UNITED STATES PATENT AND TRADEMARK OFFICE

APPLICATION NO.	FILING DATE	FIRST NAMED INVENTOR	ATTORNEY DOCKET NO.	CONFIRMATION NO.
10/680,995	10/07/2003	Larry A. Spiegel	212/507	6656
7590	08/06/2004		EXAMINER	
Crockett & Crockett Suite 400 24012 Calle De La Plata Laguna Hills, CA 92653			NGUYEN, GEORGE BINH MINH	
			ART UNIT	PAPER NUMBER
			3723

DETAILED ACTION

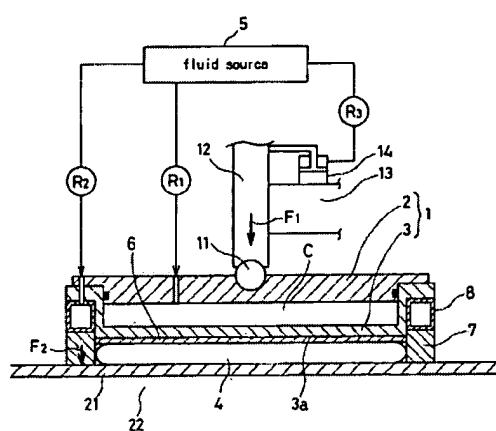
With reference to Figure 14, col. 16, lines 17-45, Katsuoka discloses the claimed invention except for the ridge extending into the groove.

Please note that in the specification, page 14, 1st paragraph, Applicant discloses that the ridge is to help the inflatable bladder to very closely conform to the size of the groove. Applicant has not disclosed that closely conforming to the size and shape of the groove would solve any problems or would significantly provide unexpected results. Please also note that inflatable bladder 8 of the prior art closely conforms to the size and shape of the groove. Thus, it would have been an obvious matter of design choice to change the shape to the groove, since applicant has not disclosed that the ridge solves any stated problem or is for any particular purpose and it appears that the invention would perform well equally well with a rectangular groove of the prior art.
